Access Compliance Report

Intersection ID: 48073	Main Street: MALLARD_HIGHLANDS_DR	Cross Street: MALLARD_GLEN_DR	Location:	N
ADA ID: 5DCEA3E0E974	Ramp Type: PerpDiag	Initial Pass/Fail: Fail	Overall Compliance: No	Severity Score: 35

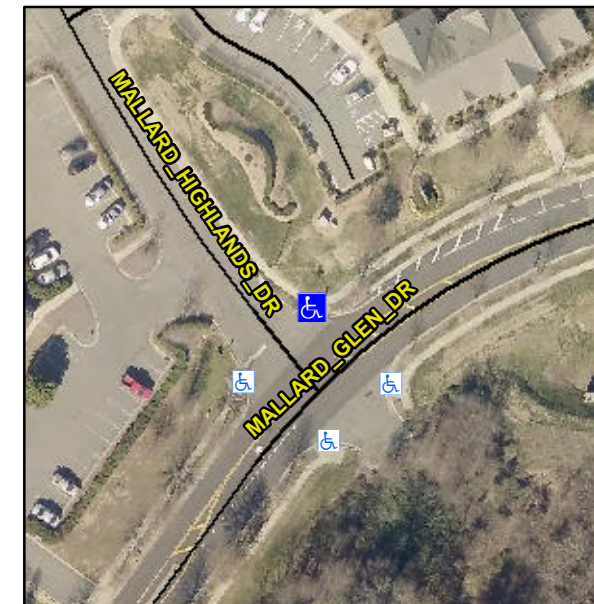
R304.5.1, R304.2.2, R304.5.3

Compliance	Description	Data	Compliance	Description	Data
N/A	Ramp Length (in)	57.0	No	Ramp Slope (%)	13.2
No	Ramp Width (in)	42.5	No	Ramp XSlope (%)	3.2
N/A	Flare Type LT	N/A	N/A	Flare Type RT	N/A
N/A	Flare Slope LT (%)	N/A	N/A	Flare Slope RT (%)	N/A
N/A	Flare Traversable LT?	N/A	N/A	Flare Traversable RT?	N/A
N/A	Landing Length (in)	N/A	N/A	DWS Provided?	N/A
N/A	Landing Width (in)	N/A	N/A	DWS Contrast?	N/A
N/A	Landing Slope (%)	N/A	N/A	DWS Length (in)	N/A
N/A	Landing X Slope (%)	N/A	N/A	DWS Full Width?	N/A
N/A	Landing Curb? (Y/N)	N/A	N/A	DWS Offset (in)	N/A
N/A	Shared Landing?	N/A			
N/A	Gutter Ponding?	N/A	N/A	Gutter Slope (%)	N/A
N/A	Gutter Lip Ht (in)	N/A	N/A	Gutter X Slope (%)	N/A
N/A	Painted X Walk1?	No	N/A	Painted X Walk2?	No
	X Walk 1 Direction	To SW		X Walk 2 Direction	To SE
N/A	X Walk 1 Width (in)	N/A	N/A	X Walk 2 Width (in)	N/A
	X Walk 1 Slope (%)	2.4		X Walk 2 Slope (%)	2.1
	X Walk 1 X Slope (%)	3.1		X Walk 2 X Slope (%)	4.9

Remove & Replace Curb Ramp With Two New Directional Ramps or Equivalent.
